Project: HAMILTON-WENTWORTH DISTRICT SCHOOL BOARD
P02083
BALLARD WASHROOMS & CHANGE ROOM RENOVATIONS &
UPGRADES

P02083 W.H. BALLARD ELEMENTARY SCHOOL **HWDSB**

ADDENDUM No. S1

April 23, 2025

Proposed **Finishes**

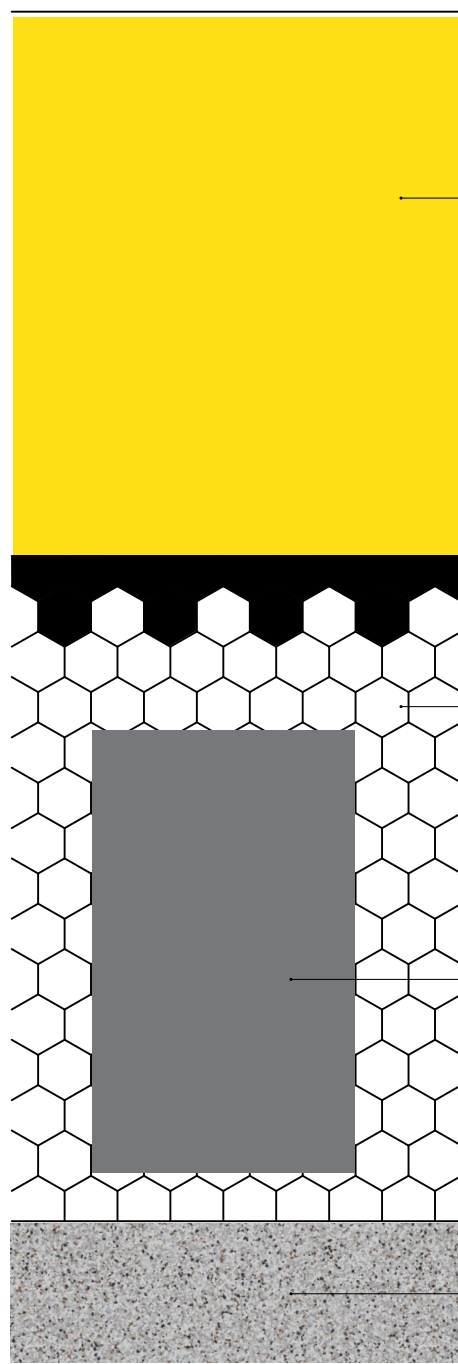
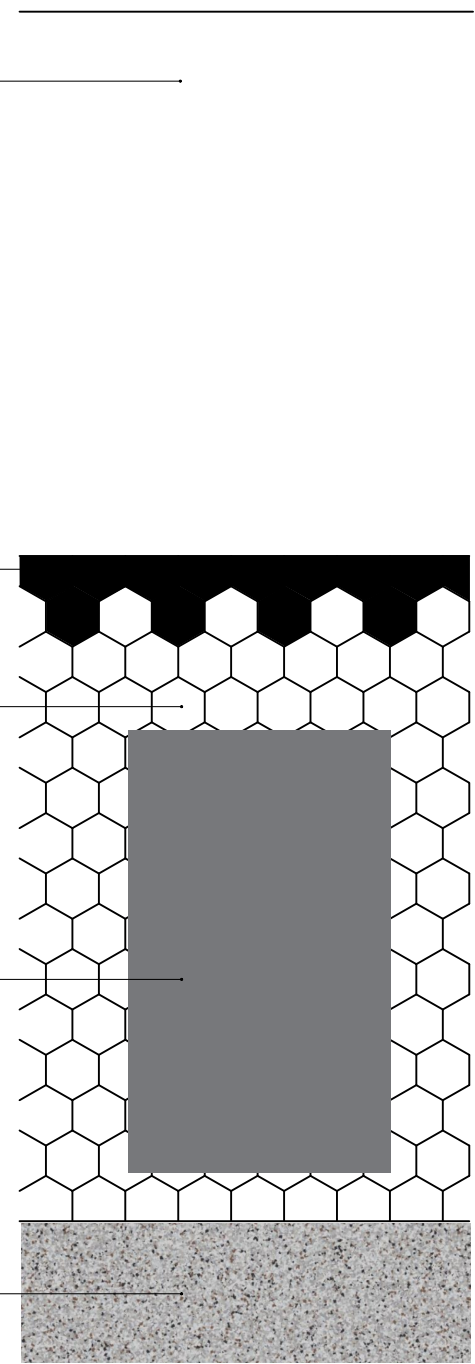
2.2. Refer to the attached sketch for the proposed finishes and wall tile pattern.

PROPOSED WASHROOM 206 FLOOR PLAN
SCALE 1:50

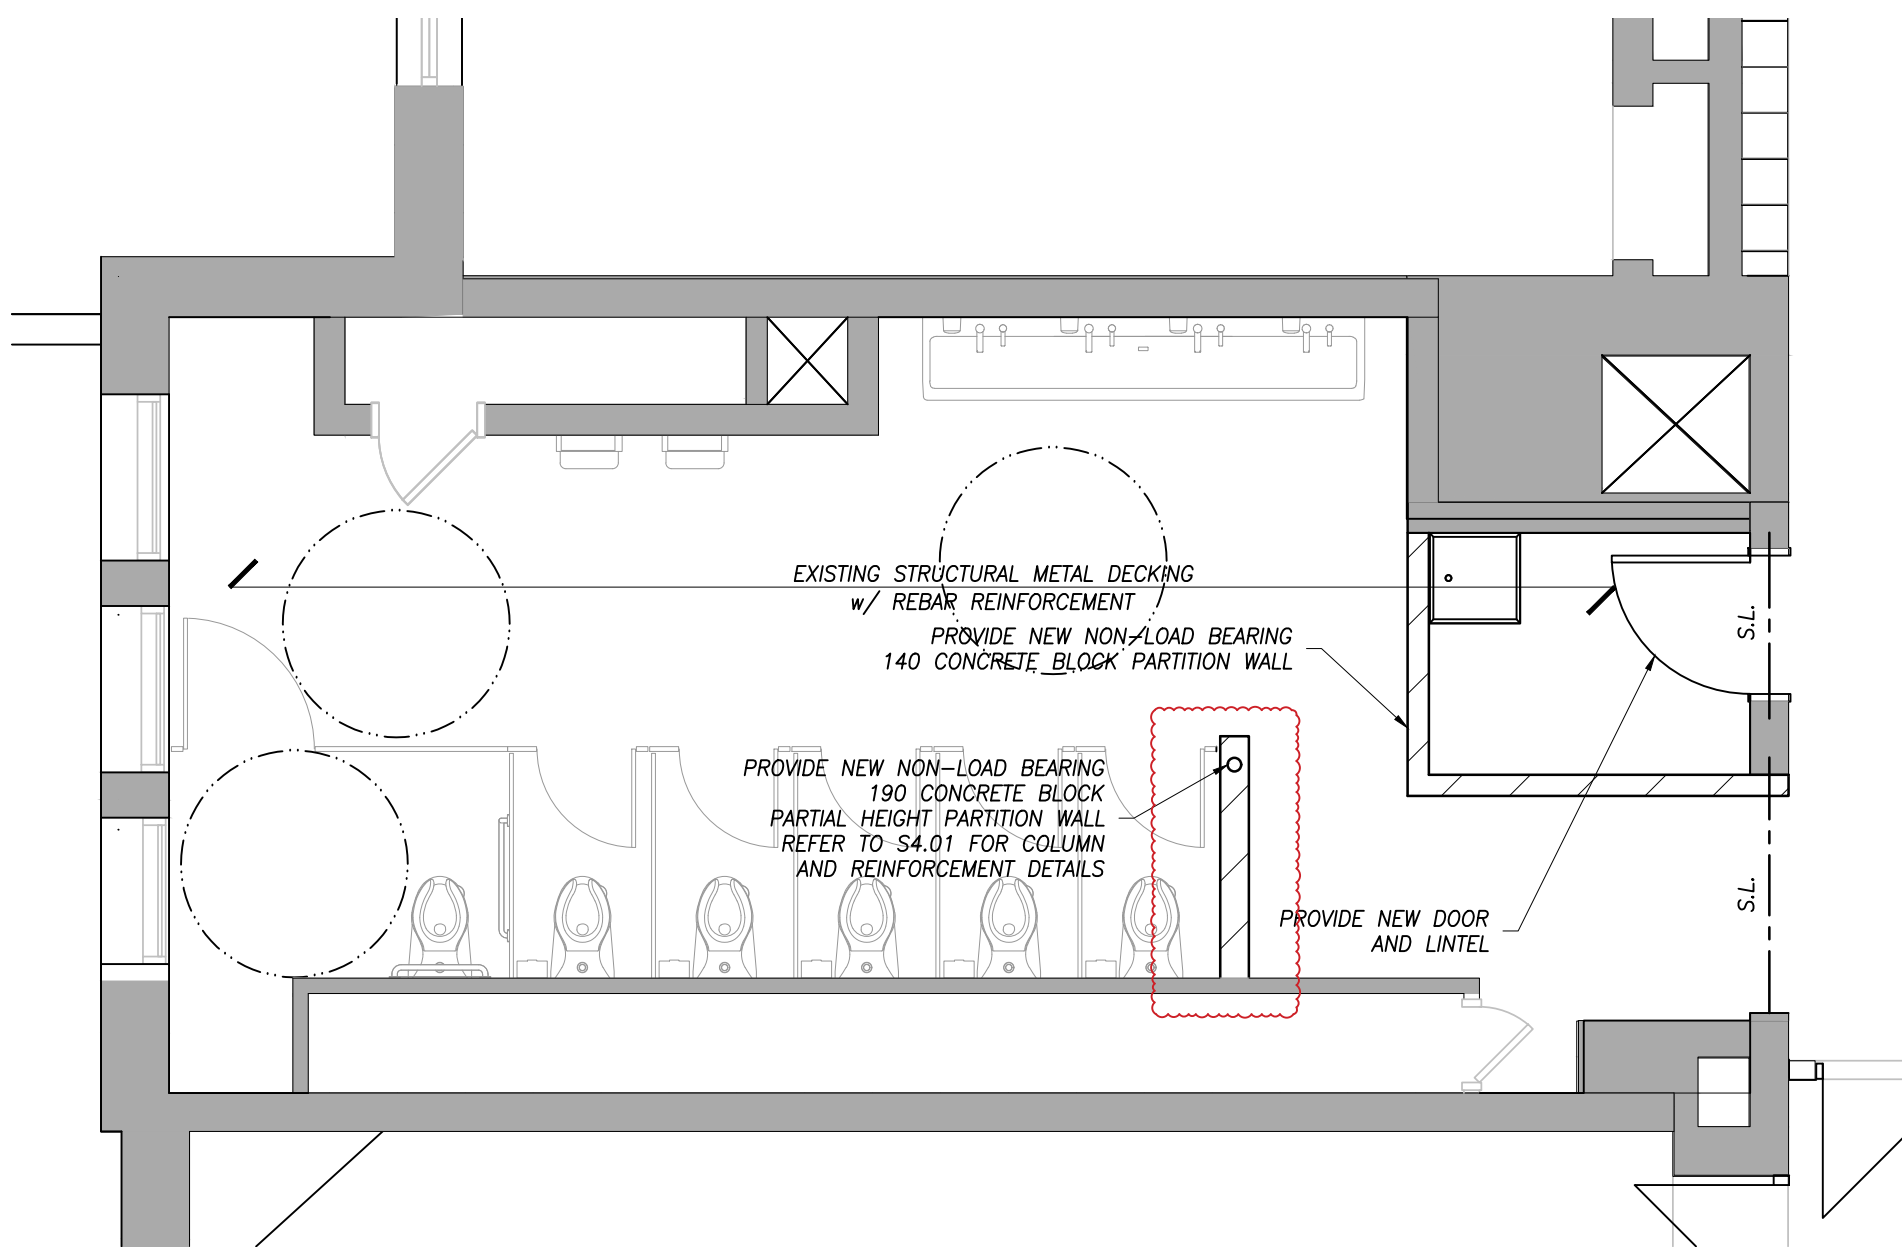
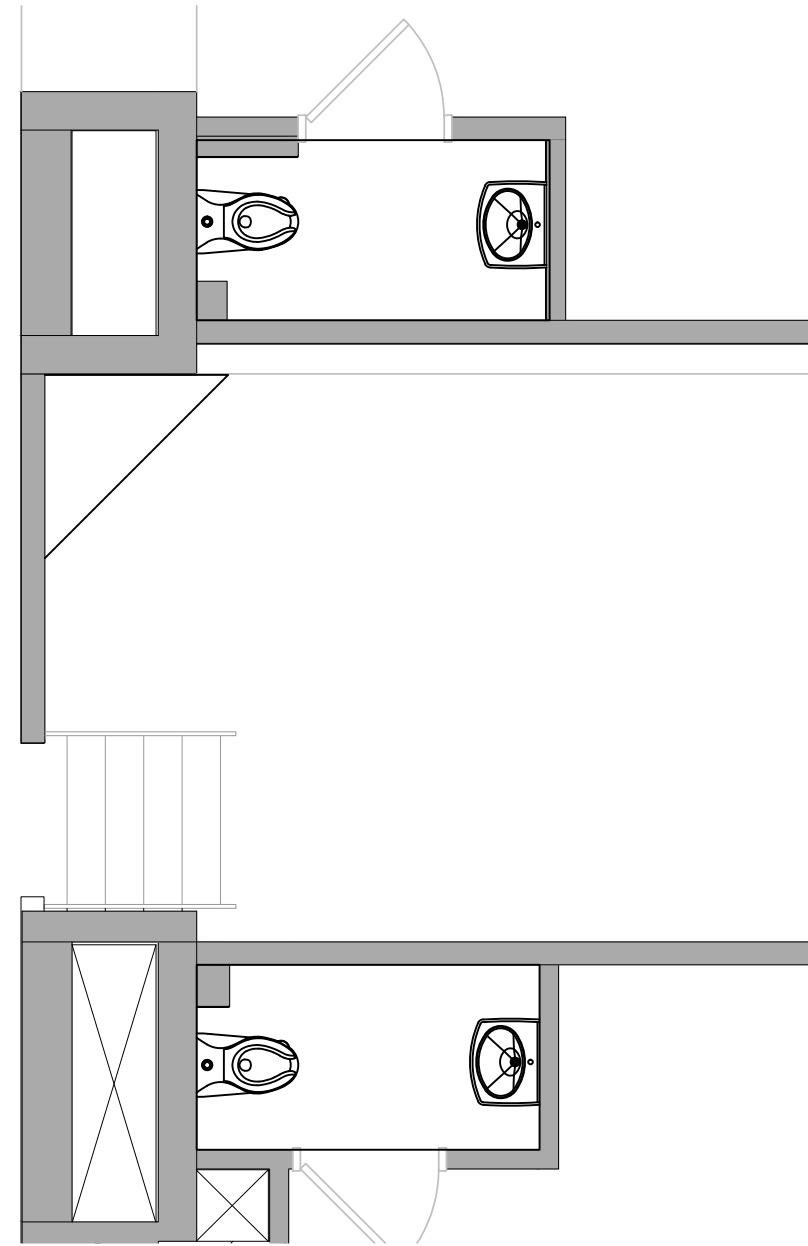
B. Drawings S1.02

- a) Proposed Floor plan for washroom 206. The partial height non-load bearing 190 concrete block wall to be constructed with bond beams at the top and bottom with 20M cont. Install 15M vertical reinforcement bars at 300mm spacing, and 15M dowels at 300mm spacing with 50mm embedment. An 89mm diameter x 6.4mm HSS column shall be embedded into the block cores and extend the full height to the

underside of the ceiling. Refer to the typical column and masonry anchorage detail, base plate detail and partial-height block detail

PROPOSED WASHROOM 314 & 315 FLOOR PLAN
SCALE 1:50

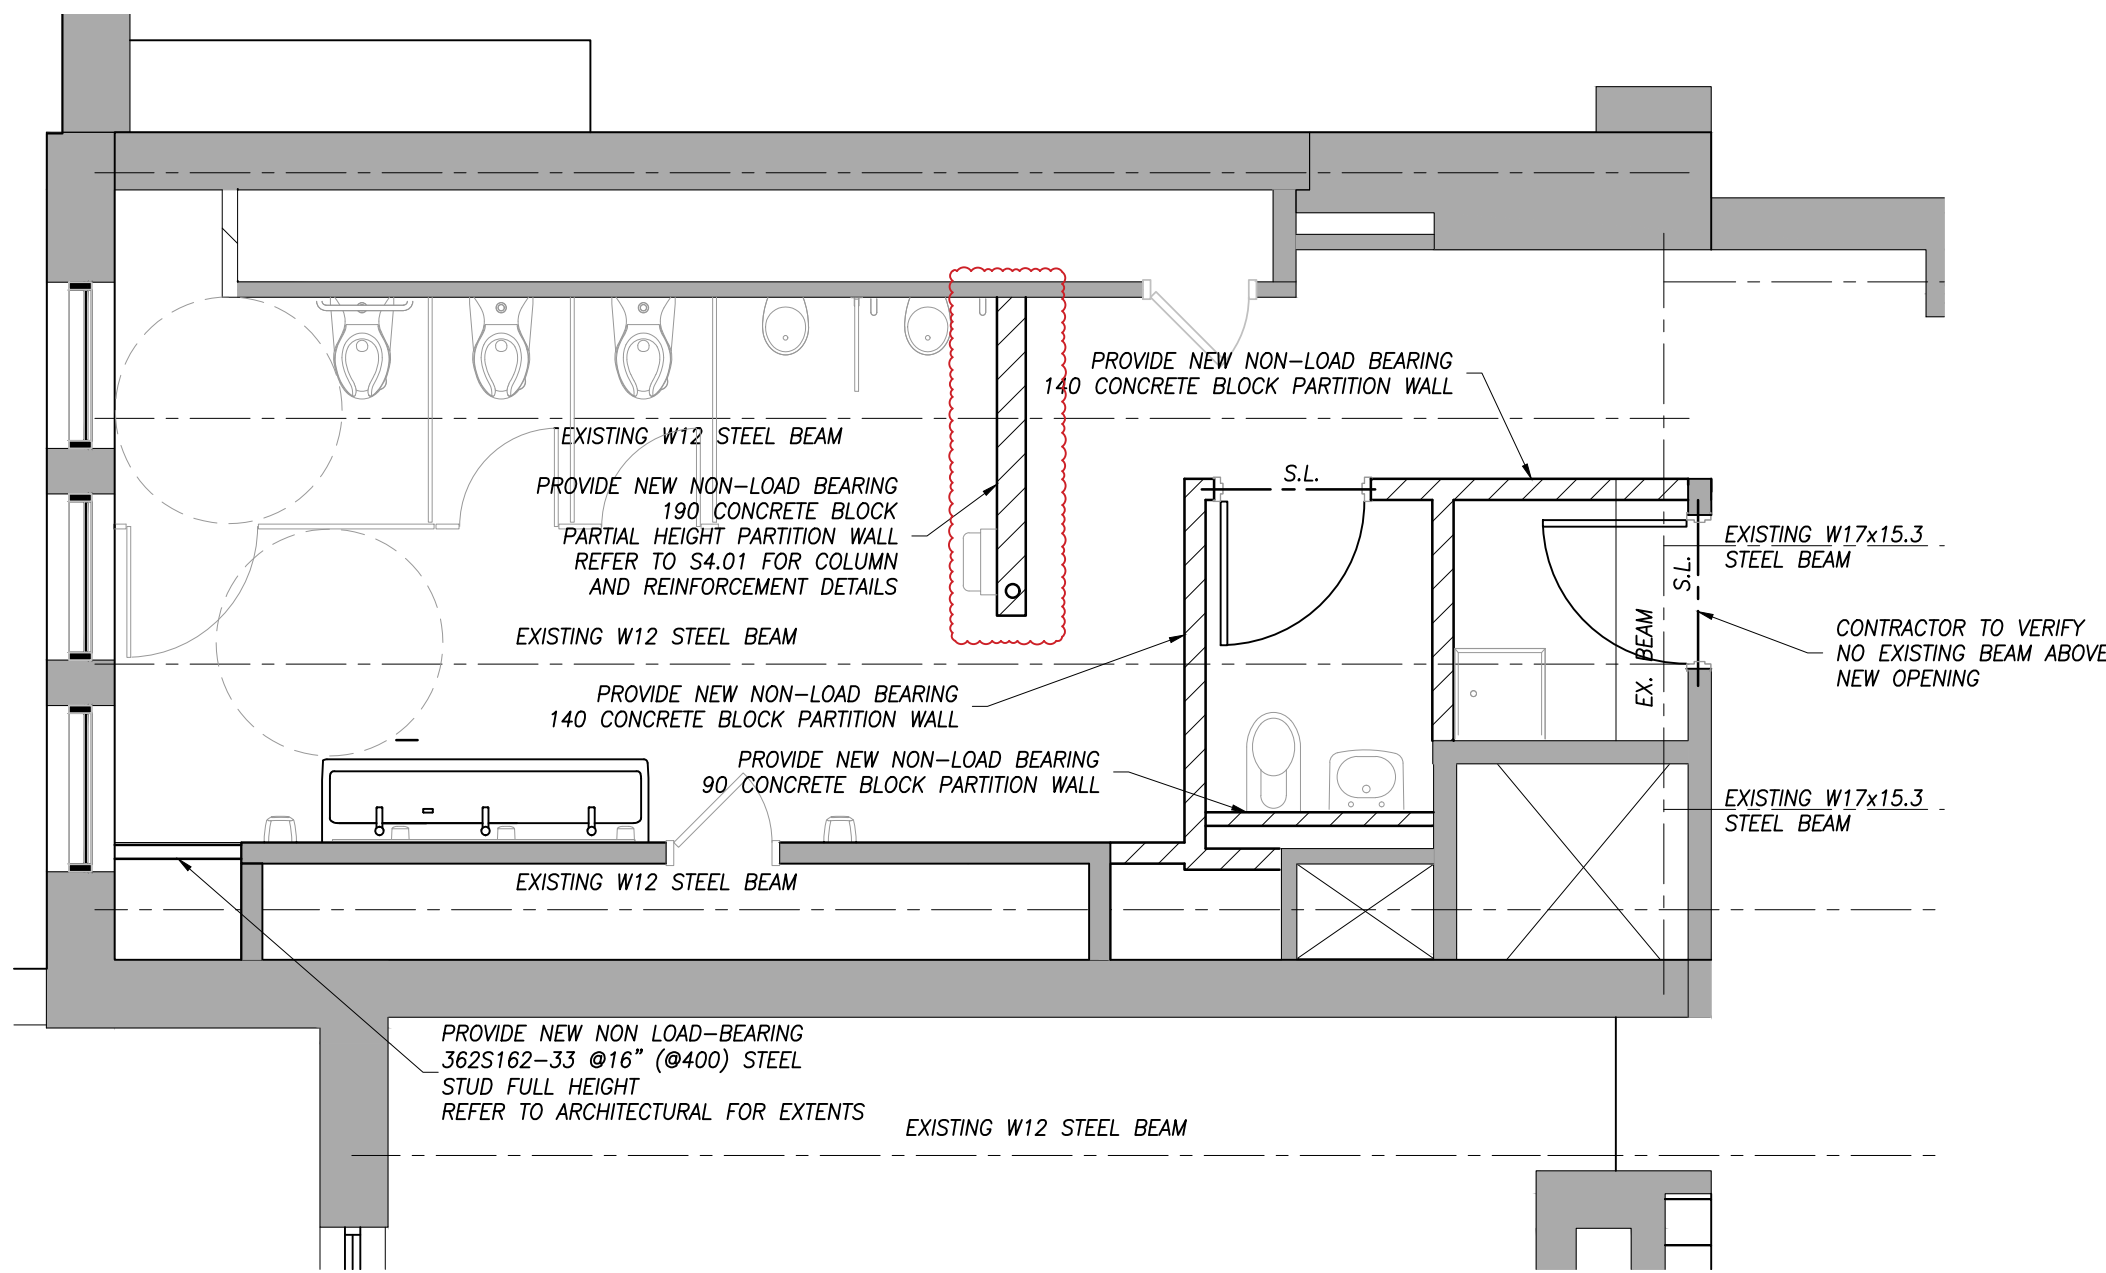
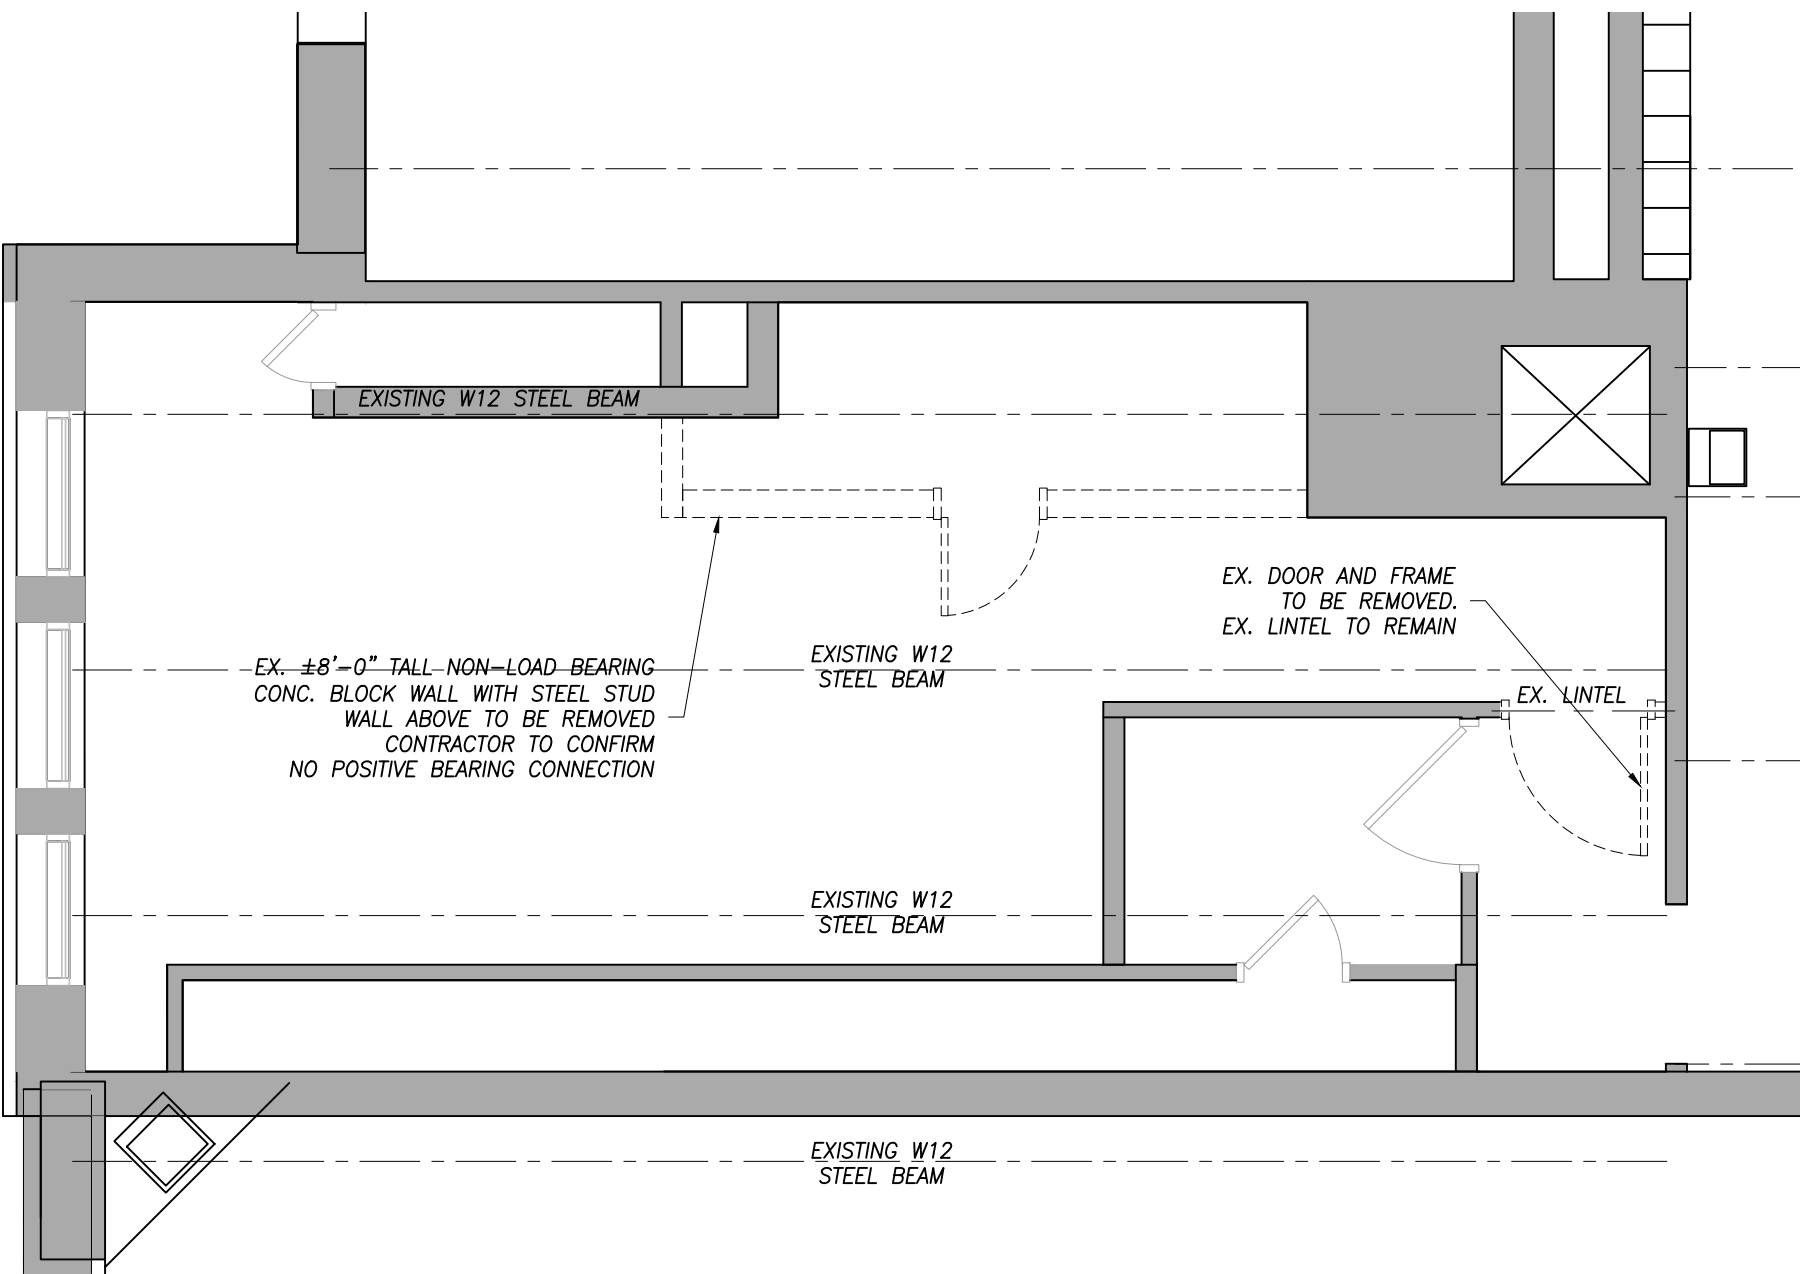
C. Drawings S1.03

- a) Proposed Floor plan for washroom 314 & 315. The partial height non-load bearing 140 concrete block wall to be revised to be 190 block and constructed with bond beams at the top and bottom with 20M cont. Install 15M vertical reinforcement bars at 300mm spacing, and 15M dowels at 300mm spacing with 50mm embedment. An 89mm diameter x 6.4mm HSS column shall be embedded into the block cores and extend the full height to the underside of the ceiling. Refer to the typical column and masonry anchorage detail, base plate detail and partial-height block detail.
